STAFF REPORT
COMMUNITY DEVELOPMENT DEPARTMENT

HEARING DATE: 3/9/2021
 TO: Mayor & City Council
 FROM: Joe Dodson, Associate Planner
 208-884-5533
 SUBJECT: H-2020-0120
 Chewie Subdivision
 LOCATION: The site is located at 2490 W. Franklin Road and the lot directly north, in the S ½ of Section 11, Township 3N., Range 1W.

Preliminary Plat consisting of six (6) industrial lots on 43.87 acres of land in the I-L zoning district, by Kent Brown Planning.

A. Preliminary Plat (dated: 11/13/2020)

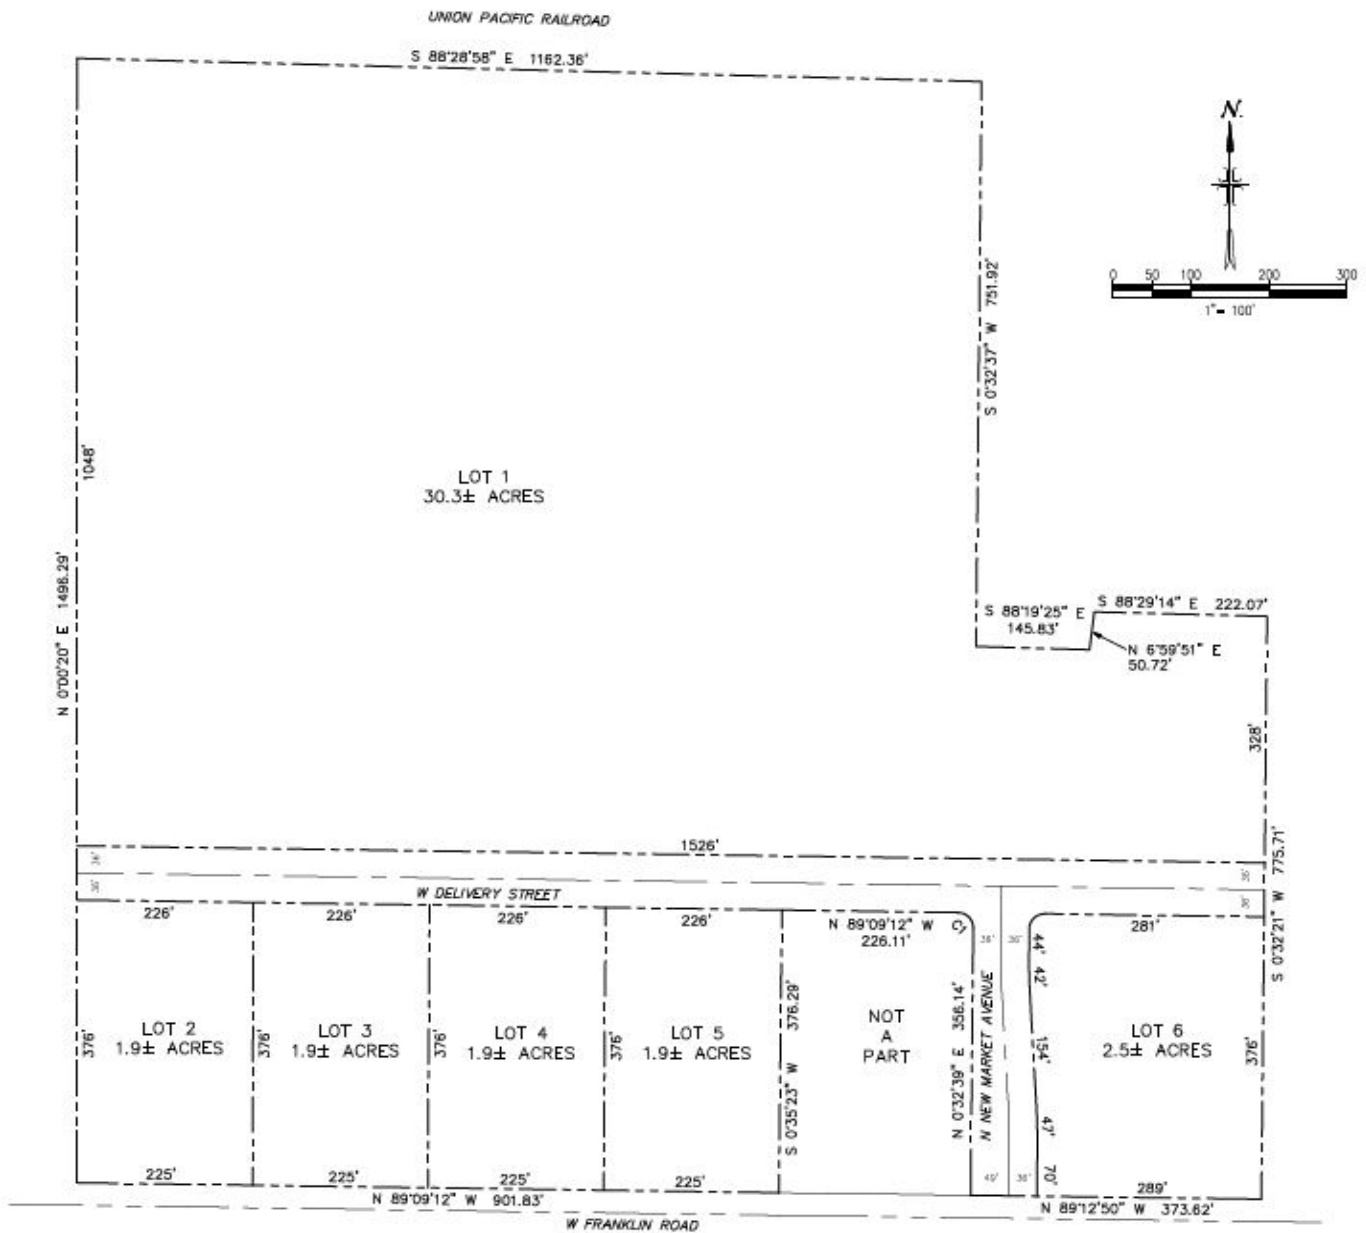
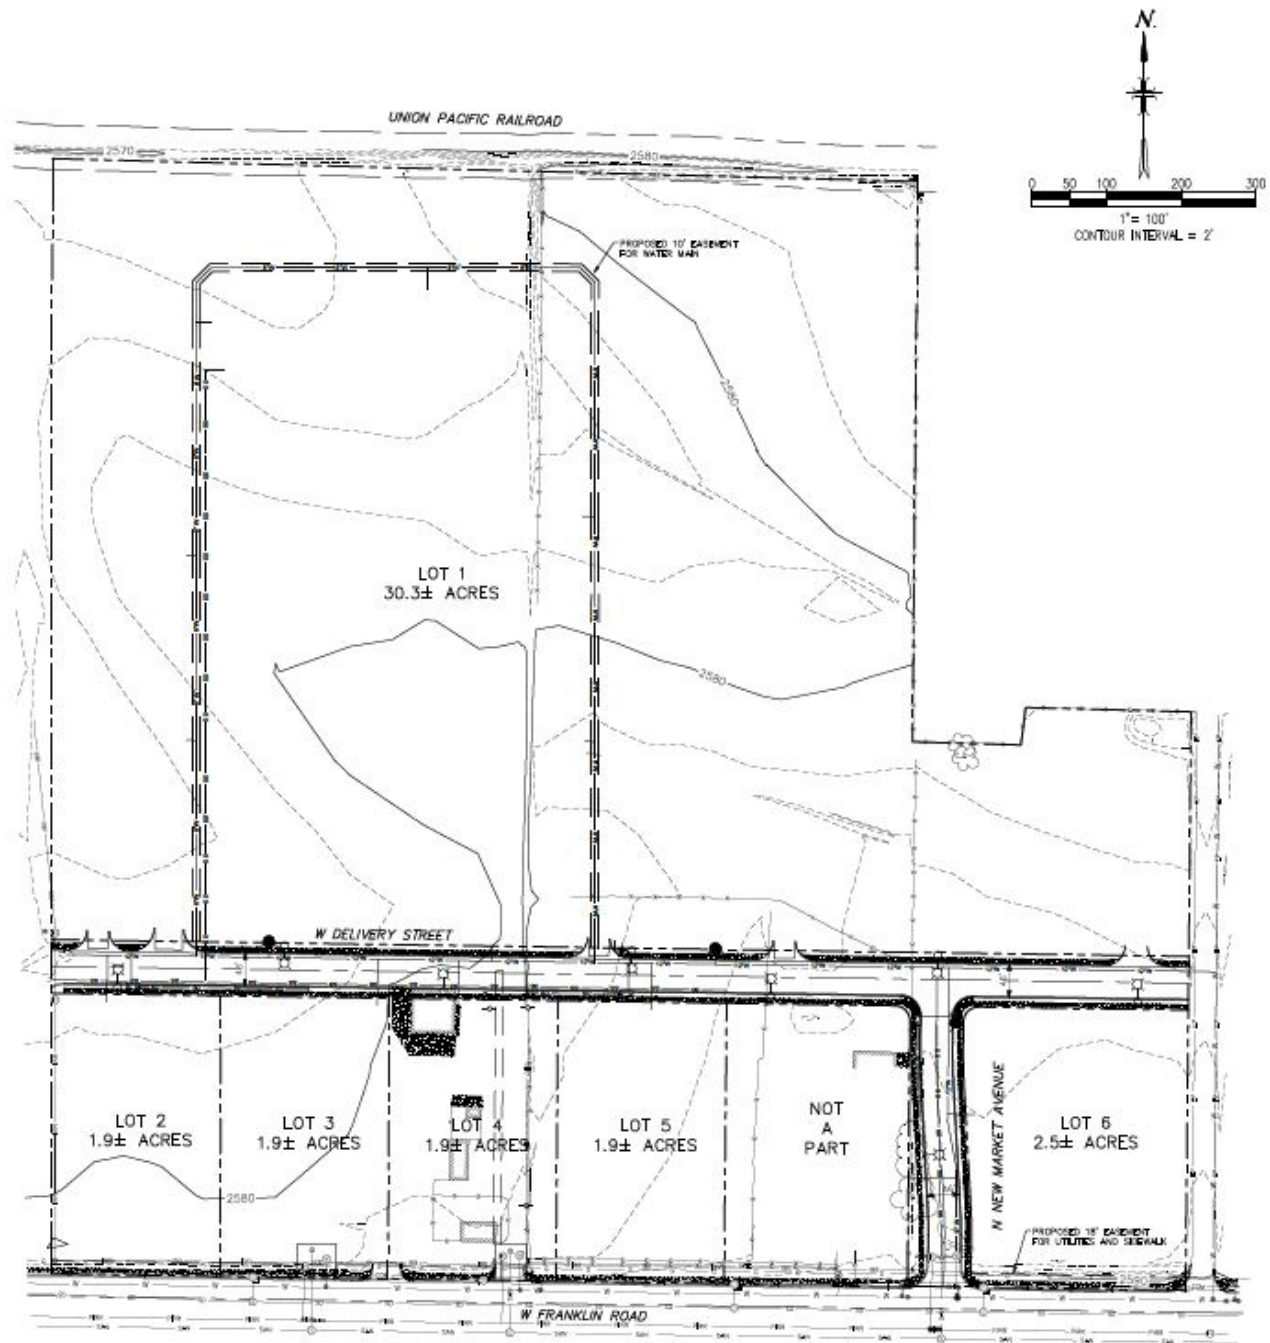
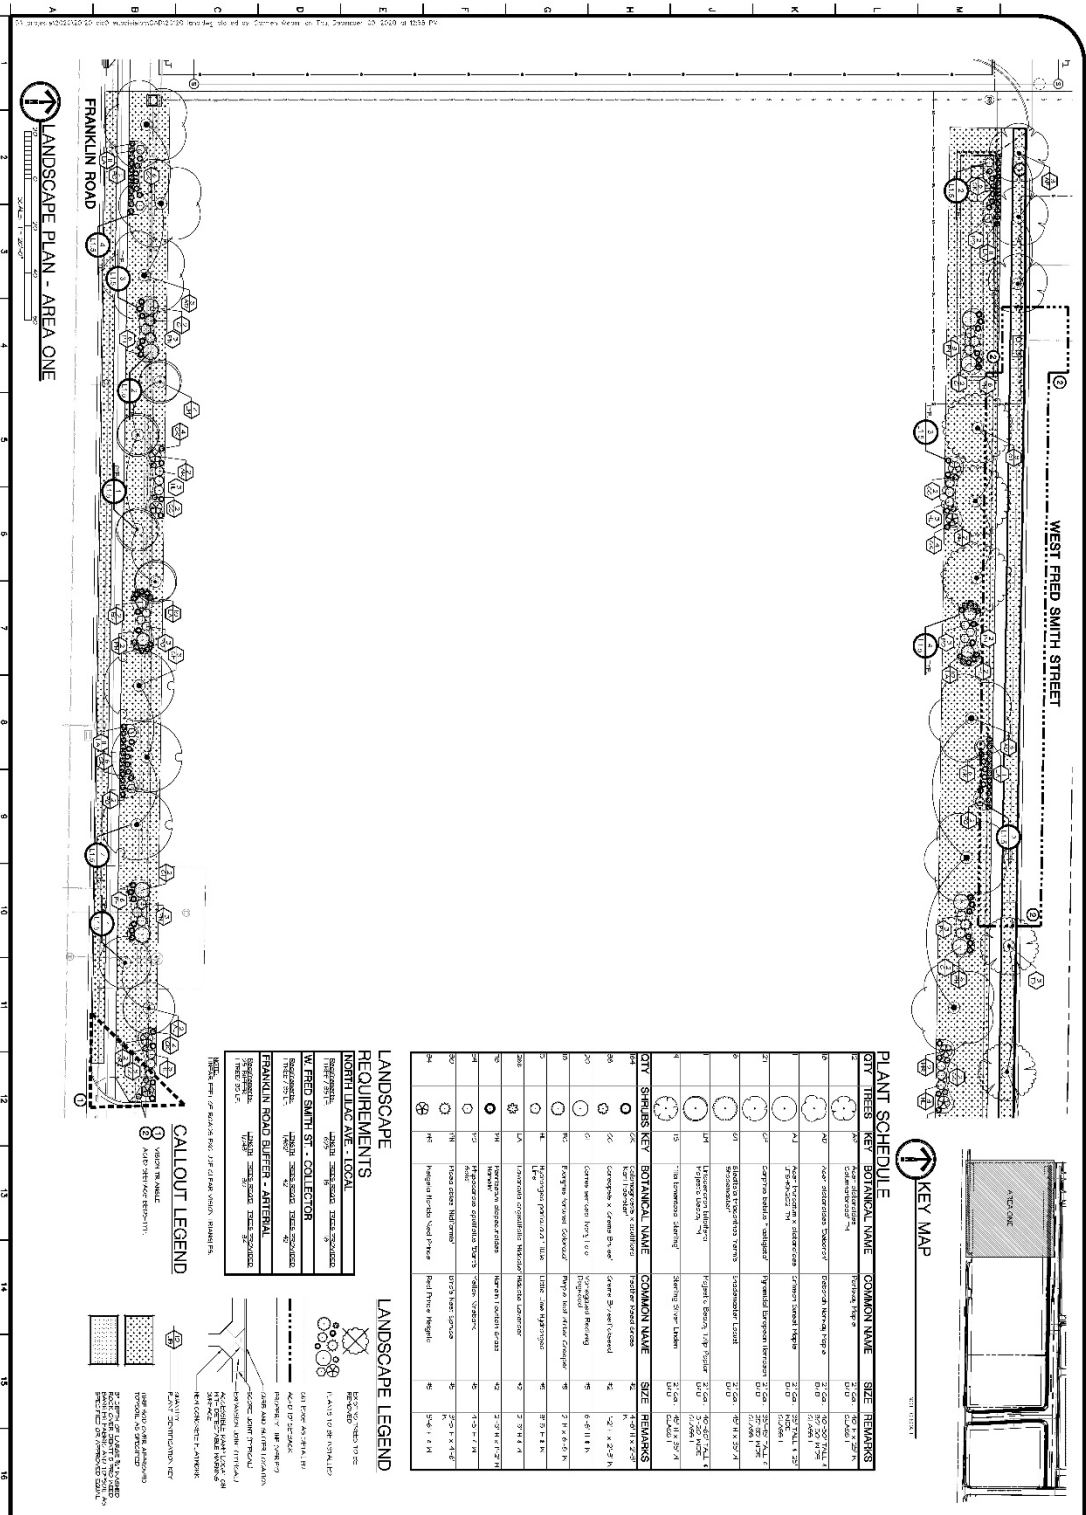
Other than the road extension and access points discussed within the TIS, the submitted plat and landscape plan show the existing accesses to Franklin to remain which does not align with code as they will have a lesser classified street (Fred Smith Street is a collector) to take access from. Therefore, these accesses should be closed with curb and gutter upon construction of the new

collector roadway. As noted, there is a lot that this preliminary plat surround and contains an existing home that is legal but nonconforming in the I-L zoning district; currently, this home also takes access from Franklin. Commensurate with Staff's previous comment, this access should be closed but because this parcel is not part of this application, Staff cannot require this access to be closed. However, this Applicant should provide a curb cut for this property along the extended W. Fred Smith Street so that when this "outparcel" does redevelop in the future, it will have access to the collector street instead of to Franklin, an arterial. The submitted plans do not show an access being provided to this parcel and this should be corrected prior to Final Plat submittal.

1. The preliminary plat included in Section VII.A, dated November 13, 2020, shall be revised as follows prior to Final Plat submittal:
 - a. Close the existing access points to Franklin Road shown on Lots 3 & 4, per UDC 11-3A-3.
 - b. Provide and visually show an access to the Morrow property (Parcel #S1211438440) from the new collector street, W. Fred Smith Street.
 - c. Revise the plat to show the collector street (W. Fred Smith Street) segment east of N. New Market Avenue as a private street commensurate with ACHD recommendations.
 - d. Depict the required landscape buffer easements on the plat where applicable (adjacent to Franklin Road, New Market Avenue, and W. Fred Smith Street).

- e. Revise the plat to show the required lot AND block for the proposed subdivision – submitted plat does not list any block numbers.
2. The landscape plan included in Section VII.B, dated October 16, 2020, shall be revised as follows prior to submittal of the Final Plat application:

CHEWIE SUBDIVISION
FRANKLIN ROAD
MERIDIAN, IDAHO
LANDSCAPE PLAN - AREA ONE

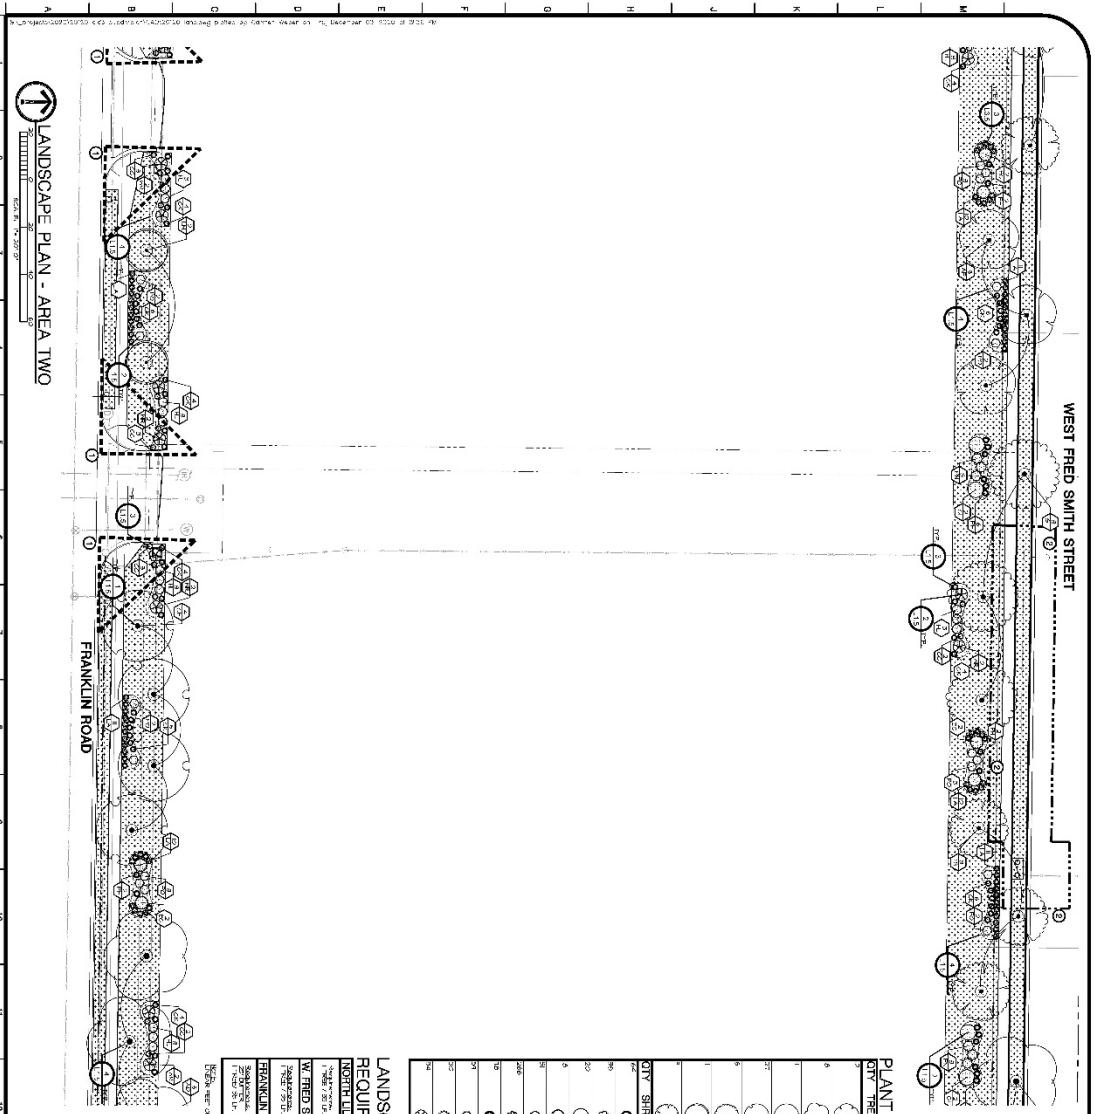
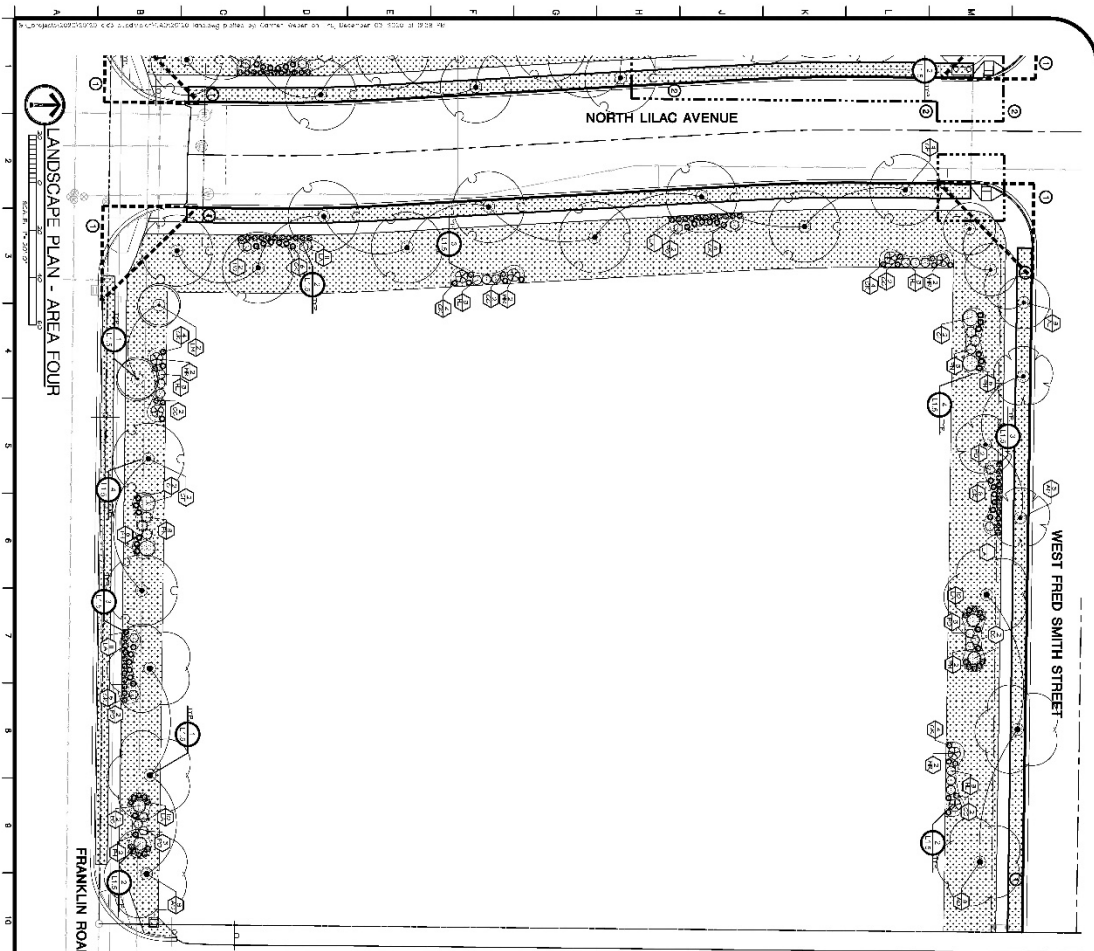
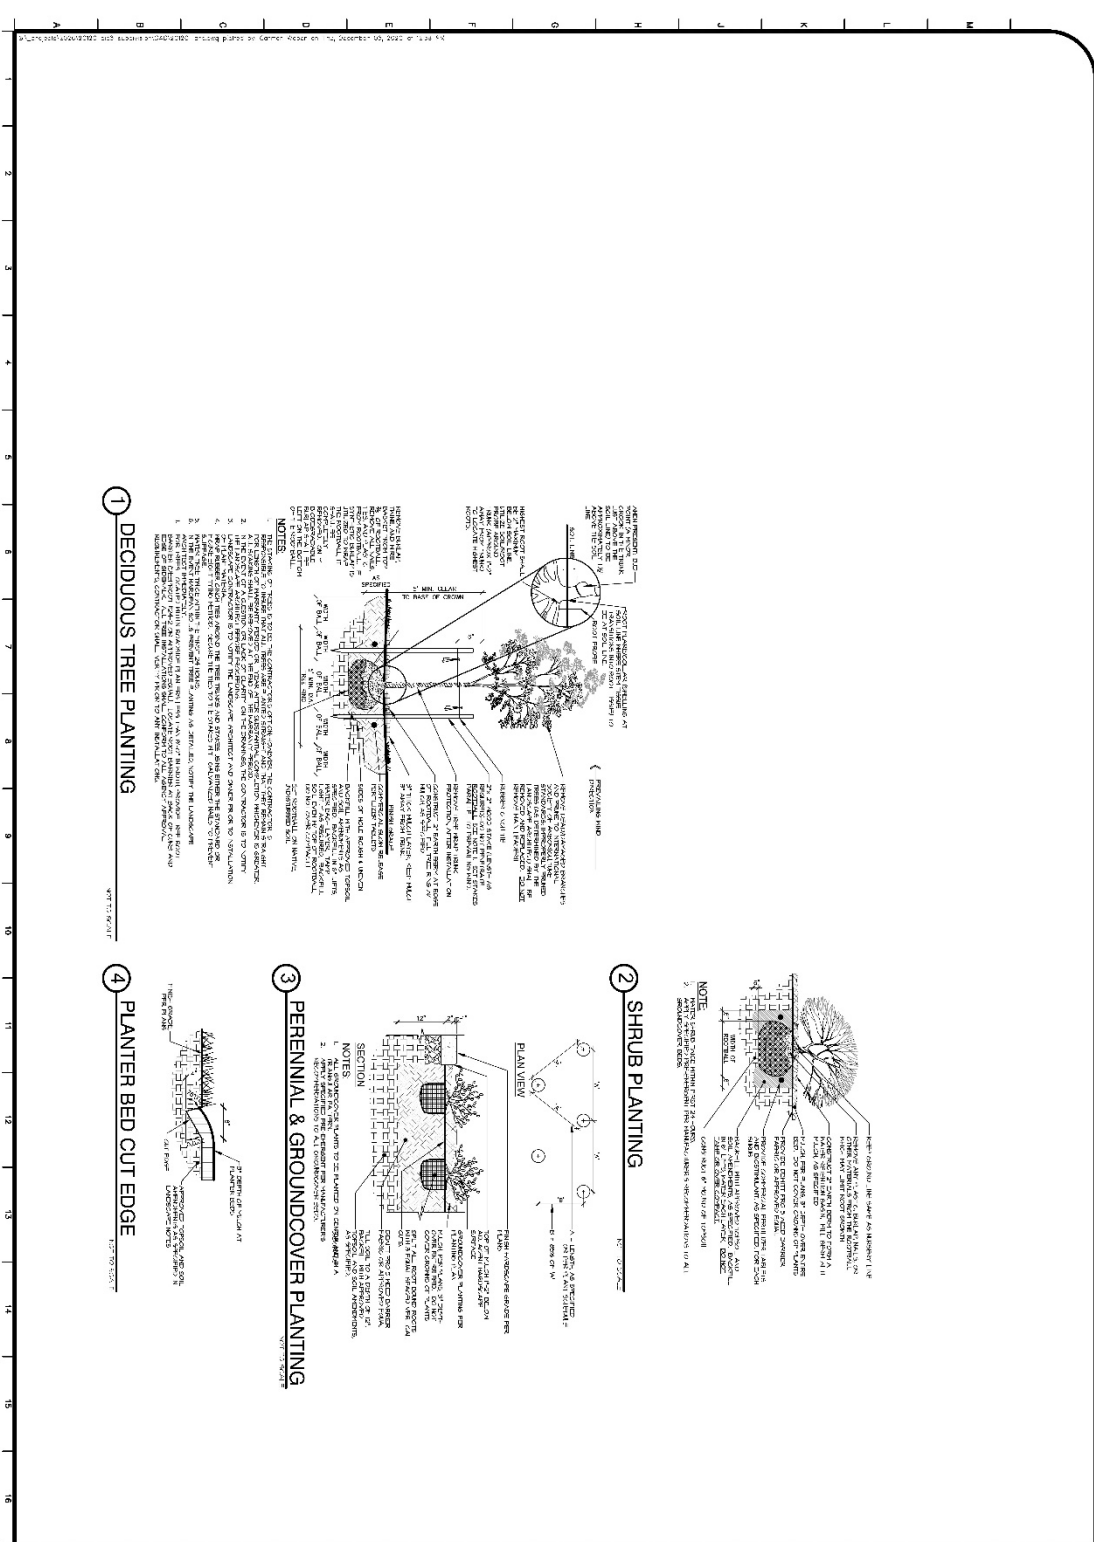
A 25-foot wide street buffer is required adjacent to W. Franklin Road, an arterial roadway, landscaped per the standards listed in [UDC 11-3B-7C](#). A 25-foot wide buffer is depicted on the landscape plans starting at the edge of right-of-way and includes the existing detached sidewalk along Franklin, meeting the UDC requirements. There is also a required 20-foot wide landscape buffer on both sides adjacent to W. Fred Smith Street, the proposed industrial collector roadway. The submitted landscape plan shows a compliant buffer on the south side but the plans do not show the north side buffer because it is being constructed with the DID3 site improvements. Commercial and Industrial areas do not require the landscape buffers to be within common lots and instead can be within easements. The submitted plat **does not** appear to show the required easements for these buffers but does show the correct amount of landscaping per the UDC standards. Staff is recommending a condition of approval to show the required buffers within easements prior to Final Plat submittal—the plat should show the easements on both sides of the collector roadway regardless of when it is being constructed.

- a. Show the required 20-foot landscape buffer on the north side of the collector street (W. Fred Smith Street) regardless of if it will be constructed with a different application.
